**CITY OF MACEDONIA
BOARD OF ZONING AND BUILDING CODE APPEALS
MEETING AGENDA
August 21, 2024**

INTEROFFICE MEMO

To: Zoning Board of Appeals
From: Chris Hall
Subject: Sign Variance Request for Villa Lago Subdivision
For Consideration by the Board on August 21, 2024
Cc: Mayor Molnar, Nino Monaco, Rachael Gambatese
Date: July 15, 2024

SUBJECT: Villa Lago – Ground Signage Replacement

VILLA LAGO SIGNS

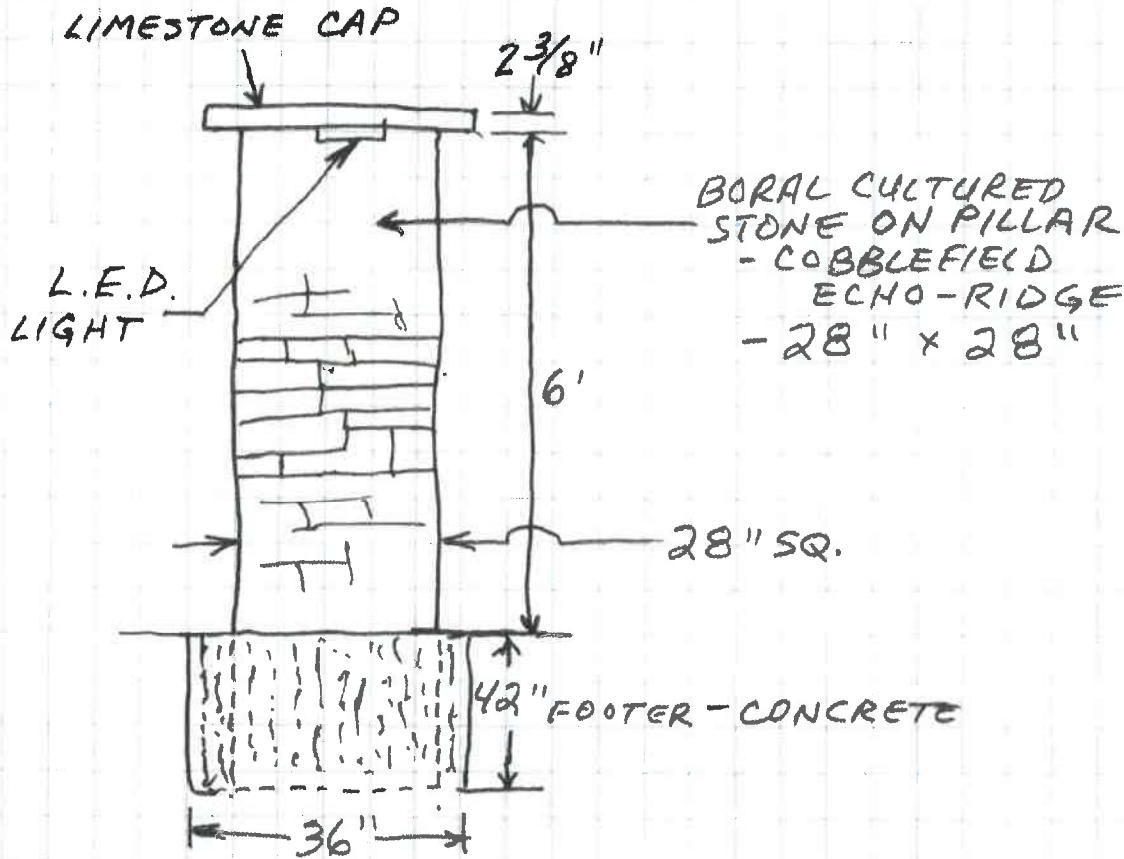
- (1) There shall be a maximum of two signs to identify a residential project, whether single or multi-family. Two signs are only permitted when the development contains two separate entrances. **ACTION ITEM: Two signs currently exist for the Villa development on opposite sides of the entrance road. However, the development does not contain two separate entrances and therefore only one identification sign is permissible.**

- (2) The maximum area shall be 24 square feet, exclusive of the sign supports or wall. The overall maximum area of the sign shall not exceed 50 square feet, inclusive of the sign supports or wall. **ACTION ITEM: The sign is proposed to be approximately 20.2 square feet and attached to six-foot-tall brick columns. The brick columns are detailed at 28 square feet each, which total 76.2 square feet when added to the 20.2 square foot sign. Therefore, the columns need to be revised to maintain compliance with the maximum of 50 square feet for the total sign area.**

- (3) Signs must only contain channel letters and cannot be cabinet style signs. The use of dynamic displays for residential developments is prohibited. **ACTION ITEM: None, the sign is made from high density urethane with raised letters.**

- (4) Signs can be illuminated by ground lights directed at the sign message. Landscaping must be integrated into the signage design and approved by the Planning Commission. **ACTION ITEM: None, the sign contains directed spotlights in a landscape bed.**

- (5) Signs, inclusive of their supports and columns, cannot exceed eight feet tall. **ACTION ITEM: None, the sign with columns is six feet tall.**

- (6) Signs shall be set back at least five (5) feet from the right-of-way and from the pavement of an entrance/exit drive. All signs shall be placed so as not to obstruct: sight lines for motorists or pedestrians; fire lanes, exits or standpipes for emergency-response vehicles; or any window such that light and/or ventilation is reduced below minimum standards required by any applicable law or building code. **ACTION ITEM: The sign is proposed to be located 20 feet from the curb, which complies with the Code. Confirmation that the sign is setback at least five feet from the right-of-way is needed.**

The existing signage is nonconforming because there are two signs for the development that only contains one entrance. Elimination of one sign is necessary to comply with the Code. Moreover, the total area of the sign exceeds the maximum permissible 50 (columns and sign) square feet and therefore must be revised to comply with the standards. Otherwise, the applicant can seek variances from the Board of Zoning Appeals.
